STANDARD DEPARTURE CHART-INSTRUMENT

RJFN / NYUTABARU

NIPPO SEVEN DEPARTURE

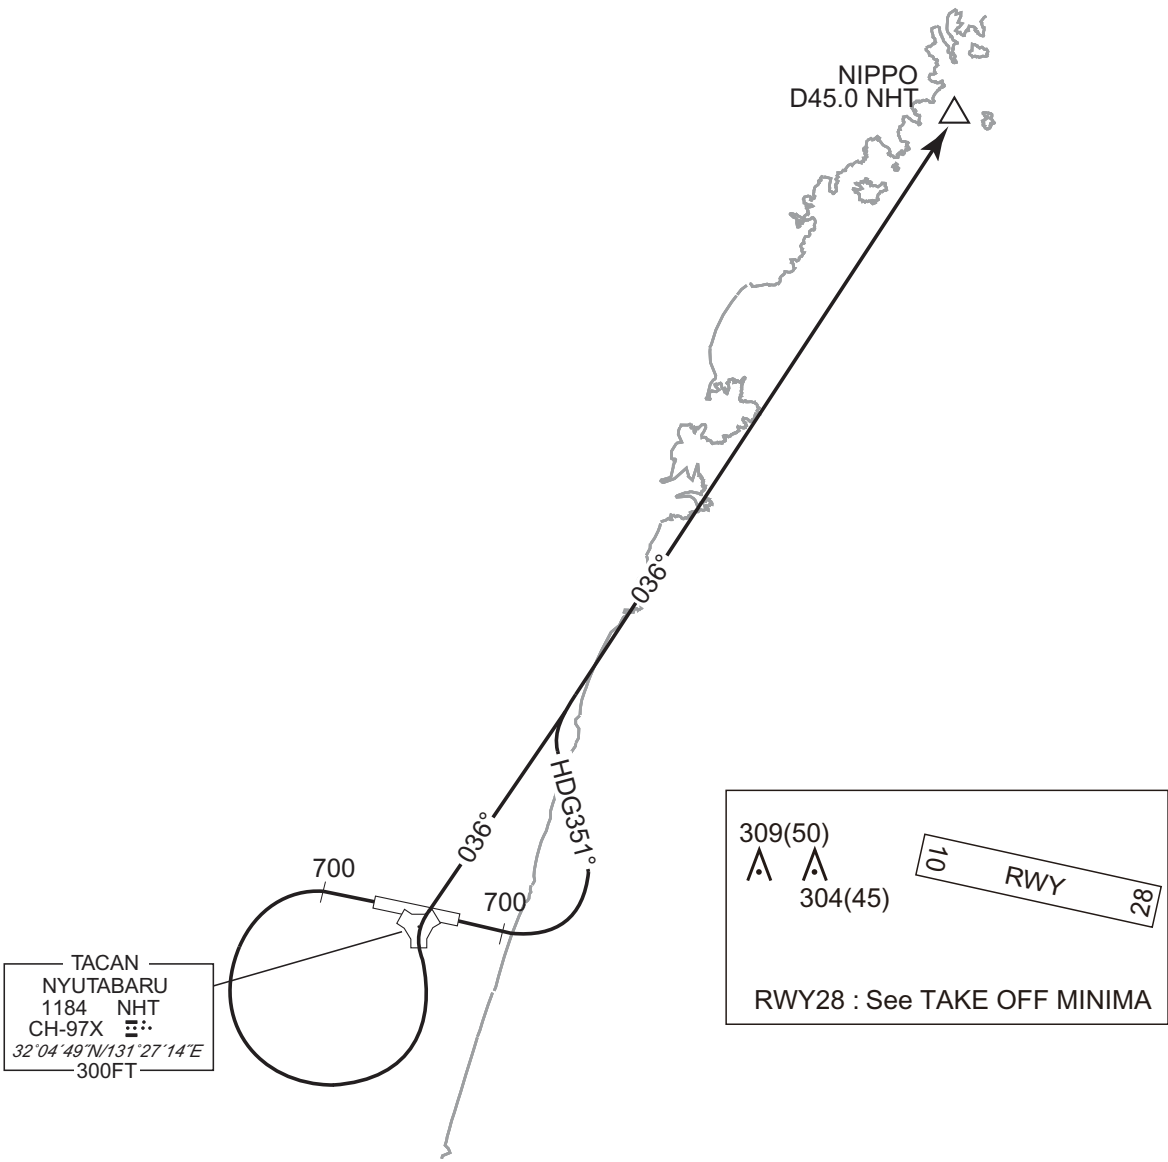
CHANGE : PROC renamed(NIPPO SEVEN DEPARTURE). PROC course(NIPPO SEVEN DEPARTURE). YATOJI TWO DEPARTURE abolished.
Restriction. Note, OBST added.

TENSO FOUR DEPARTURE

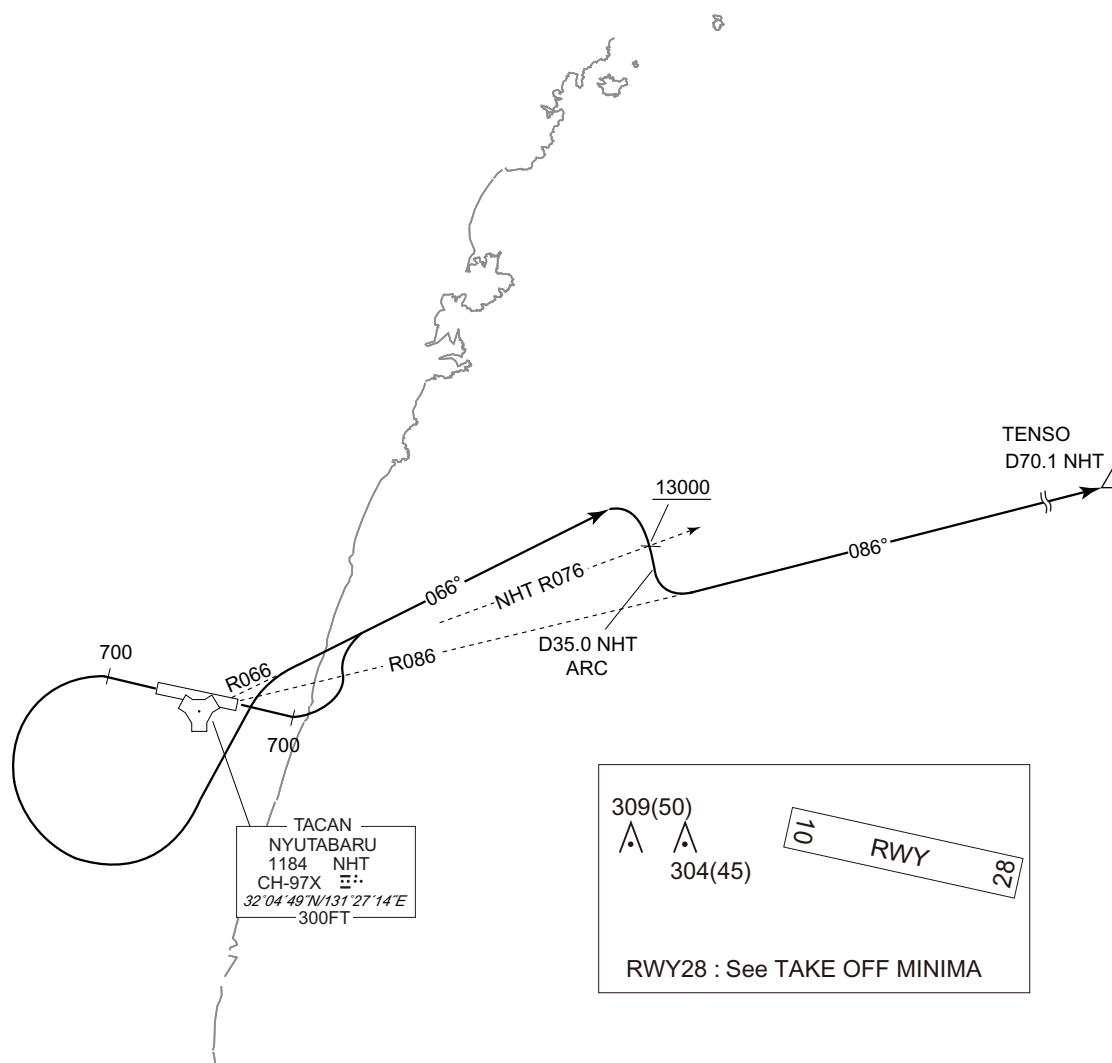
CHANGE : PROC renamed. PROC course. Restriction. Note, OBST added.

SAITO ONE DEPARTURE

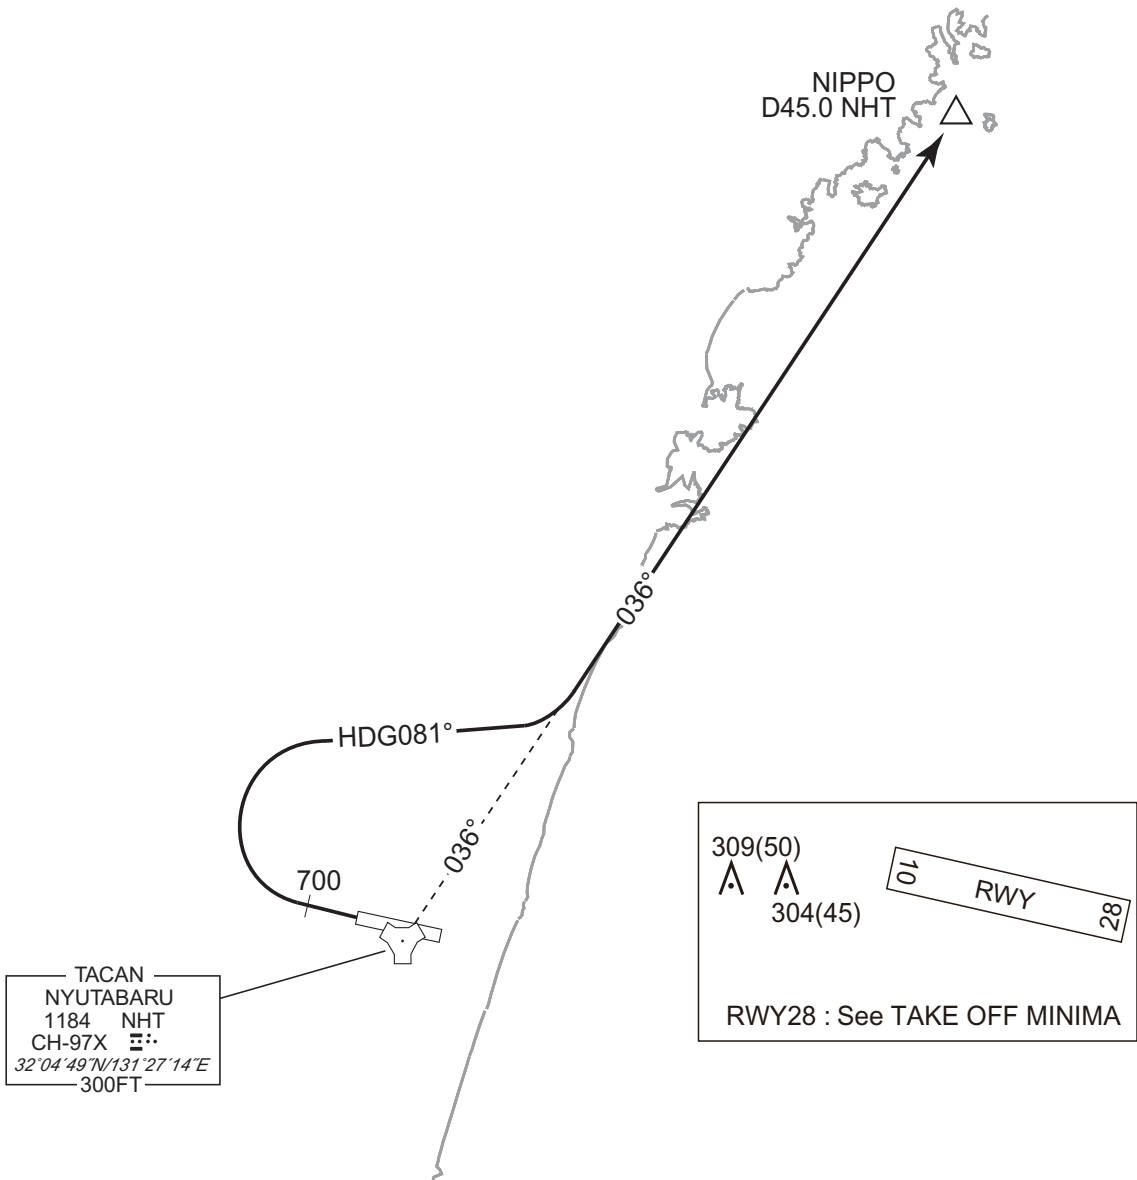
CHANGE : New PROC.

TRANSITION

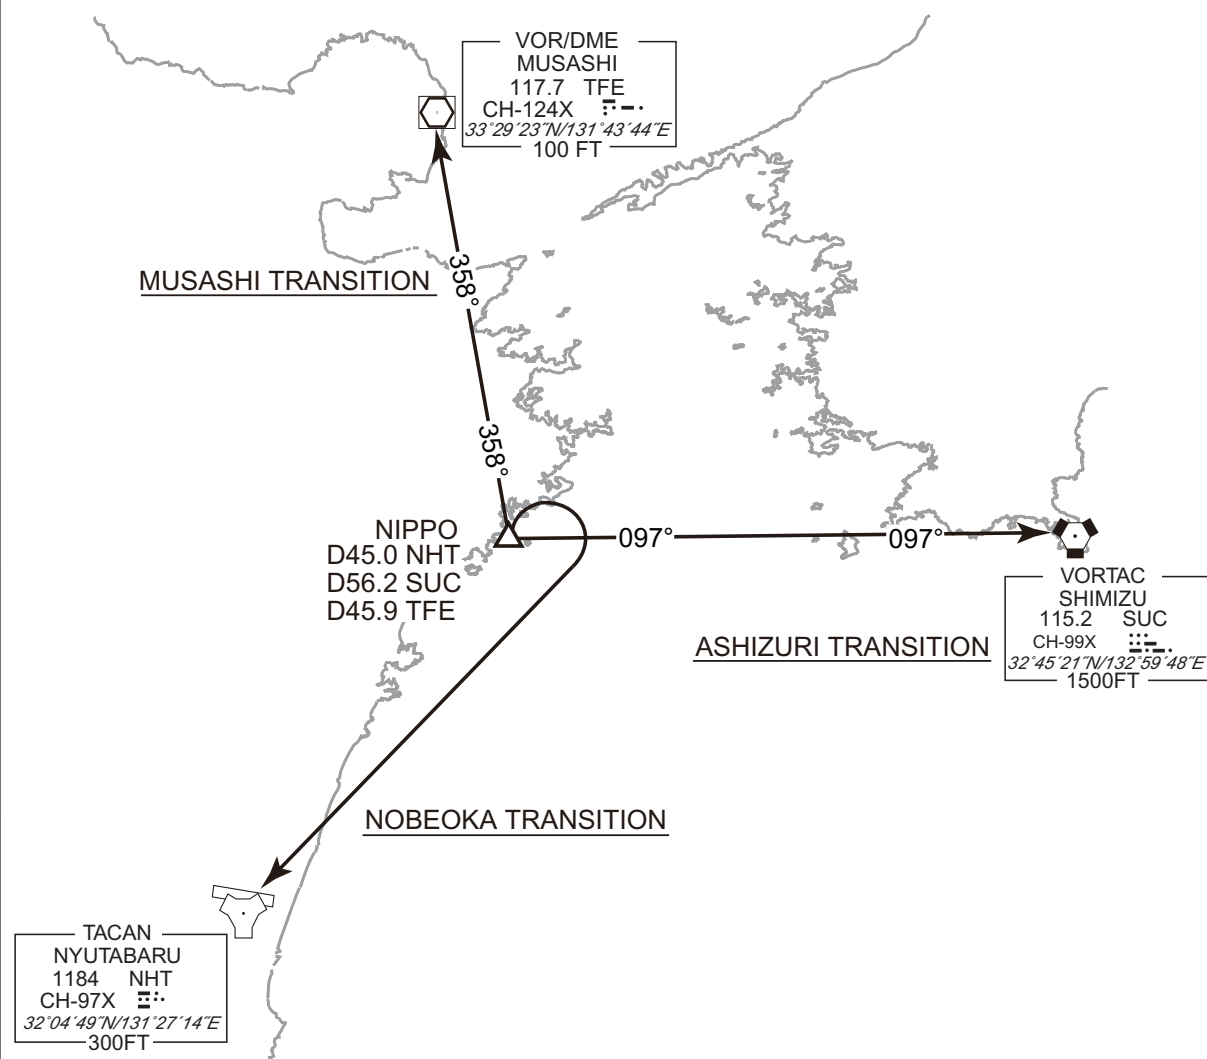
CHANGE : PROC course(NOBEOKA TRANSITION). Description of ASHIZURI TRANSITION, MUSASHI TRANSITION, MUSASHI TRANSITION. ALT restriction.
SOBO TRANSITION abolished.

TENSO ARRIVAL

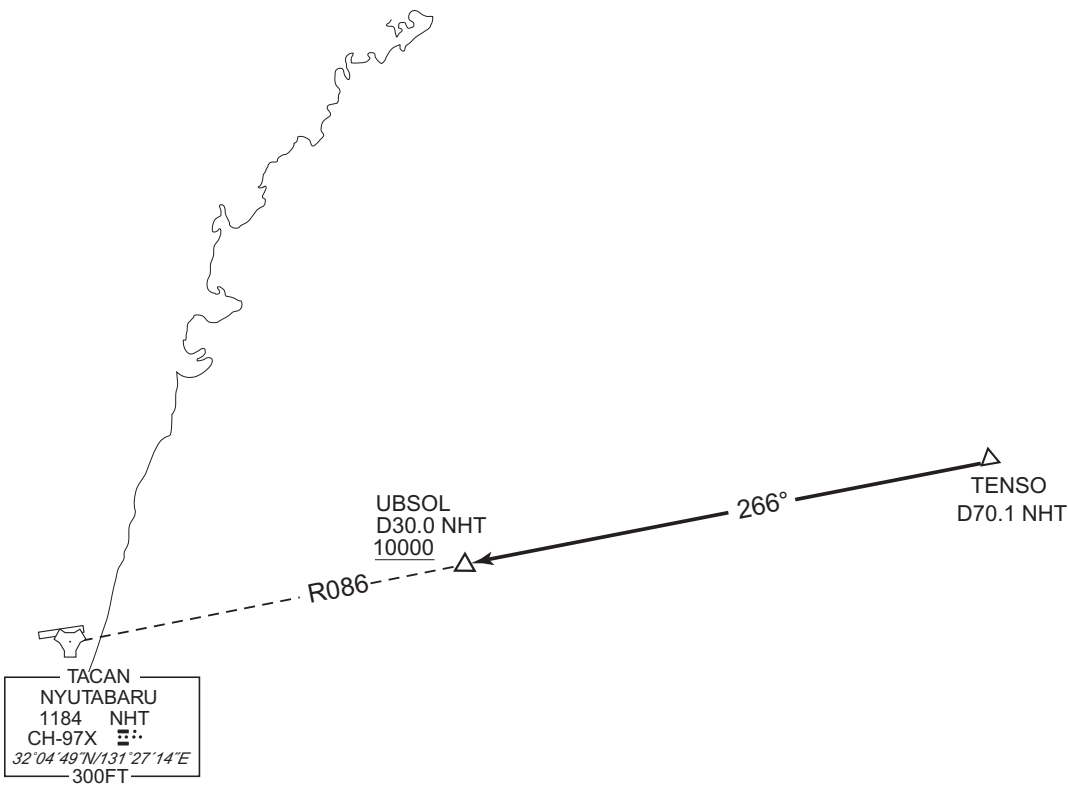
CHANGE : PROC course. UBSOL established. ALT restriction.

INSTRUMENT APPROACH CHART

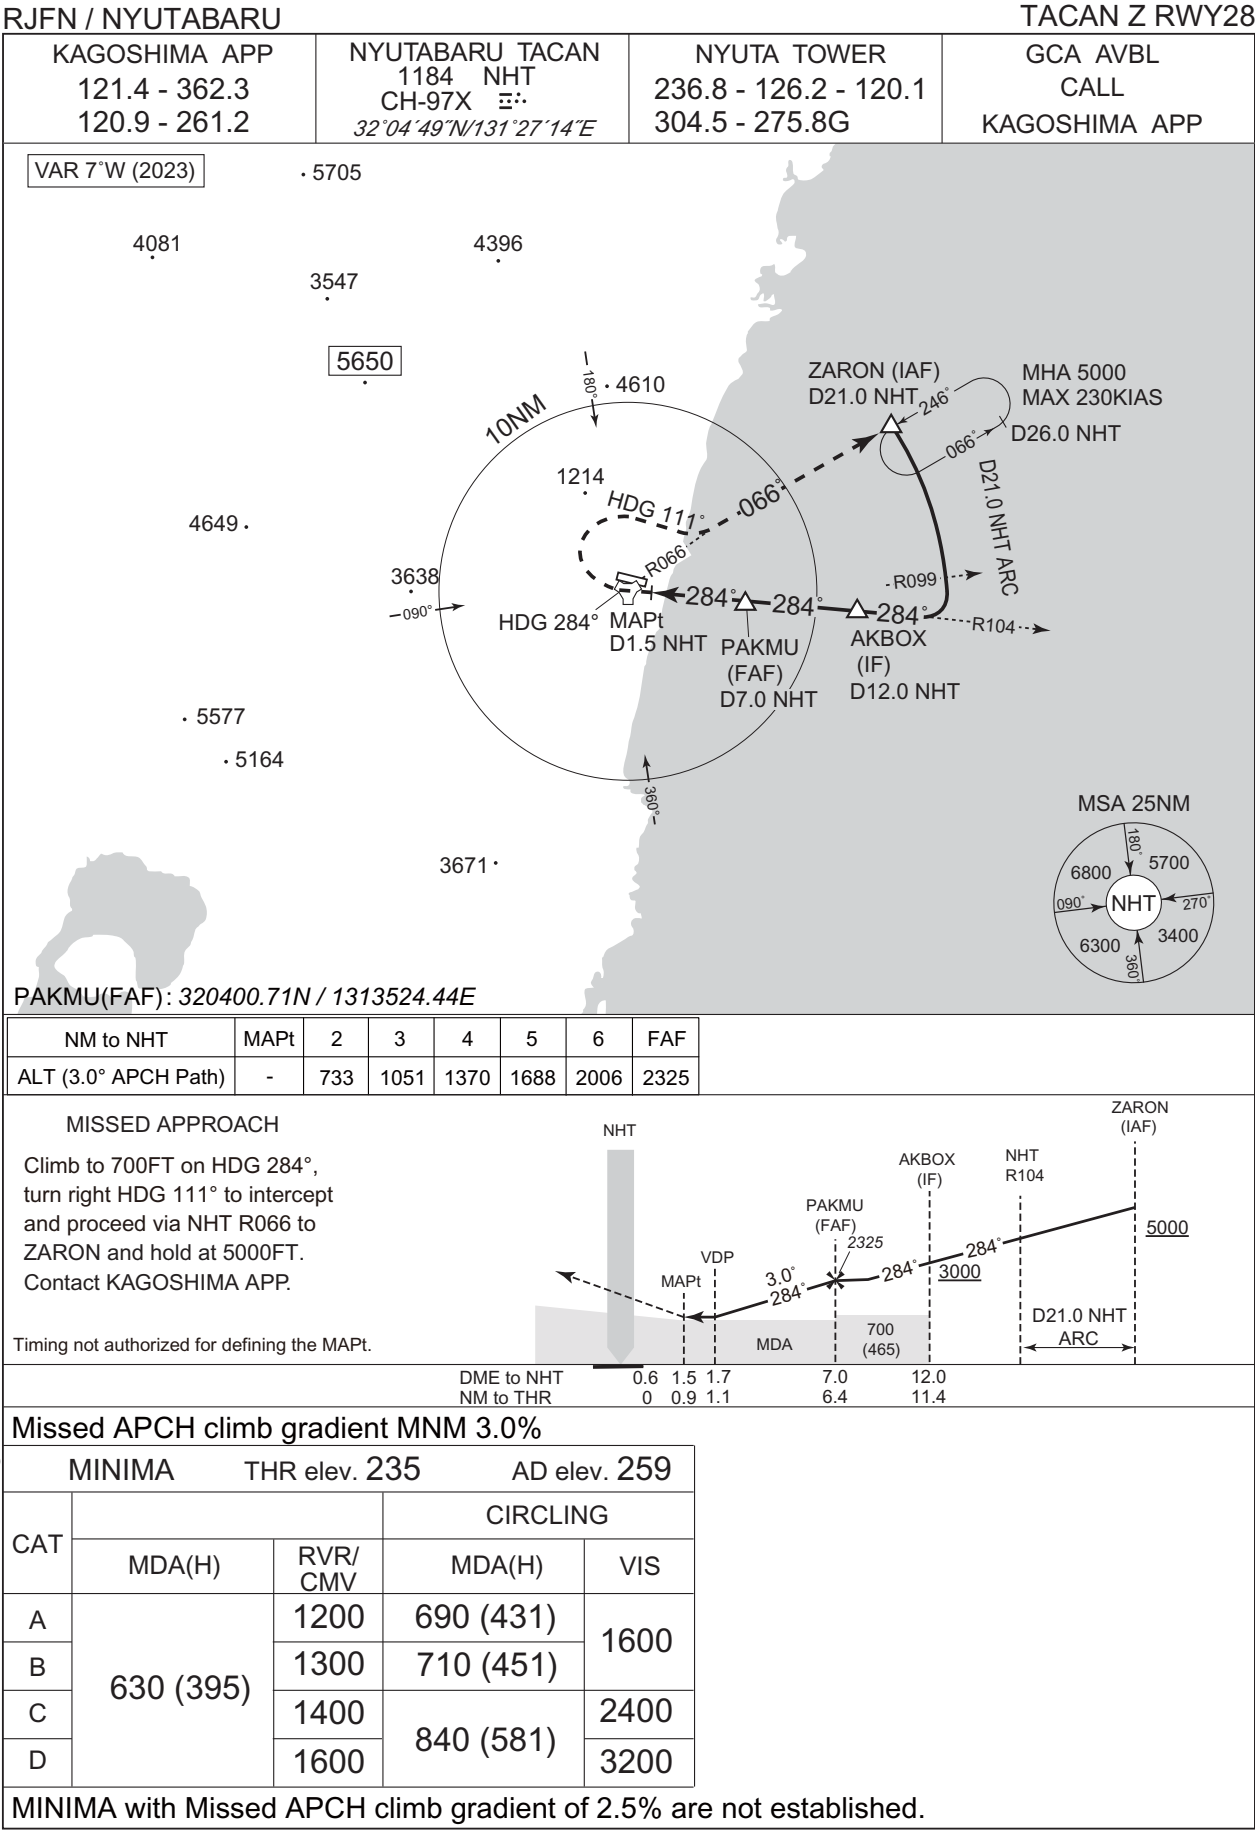
CHANGE : PROC course. Missed APCH course. MINIMA. PAKMU,AKBOX established. NM to THR. ALT(3.0°APCH Path), DME to NHT added.
Missed APCH climb gradient MNM added. VAR.

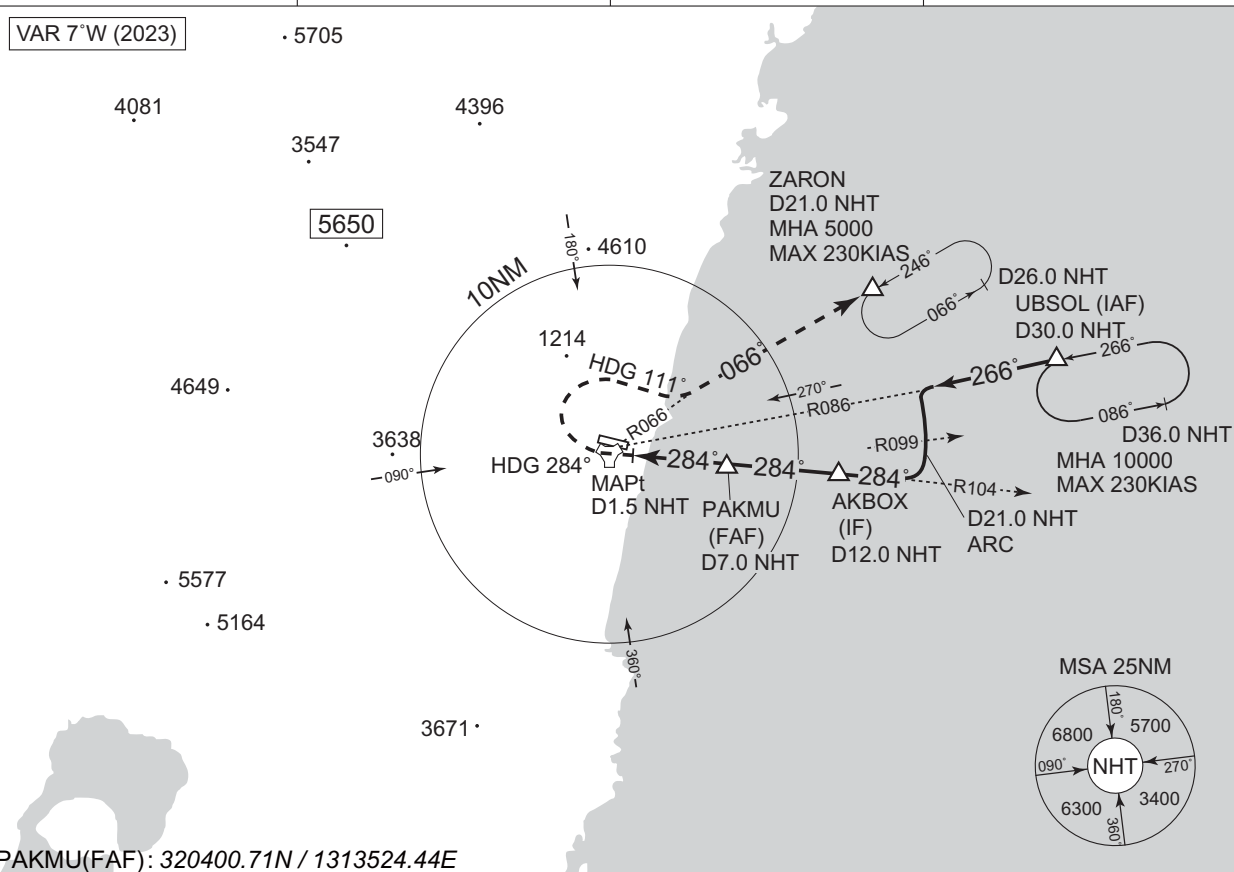
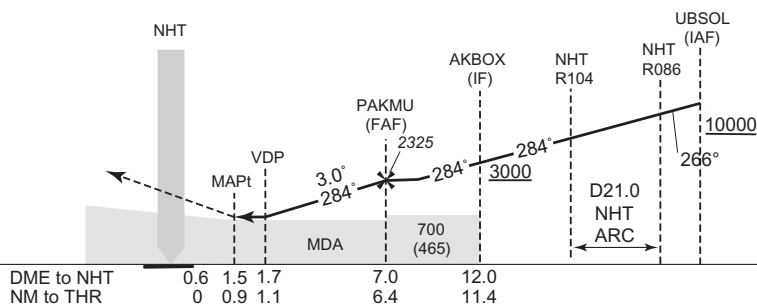
CHANGE : PROC course. Missed APCH course. MINIMA. UBSOL, PAKMU, AKBOX established. NM to THR. ALT(3.0°APCH Path), DME to NHT added.
Missed APCH climb gradient MNM added. VAR.
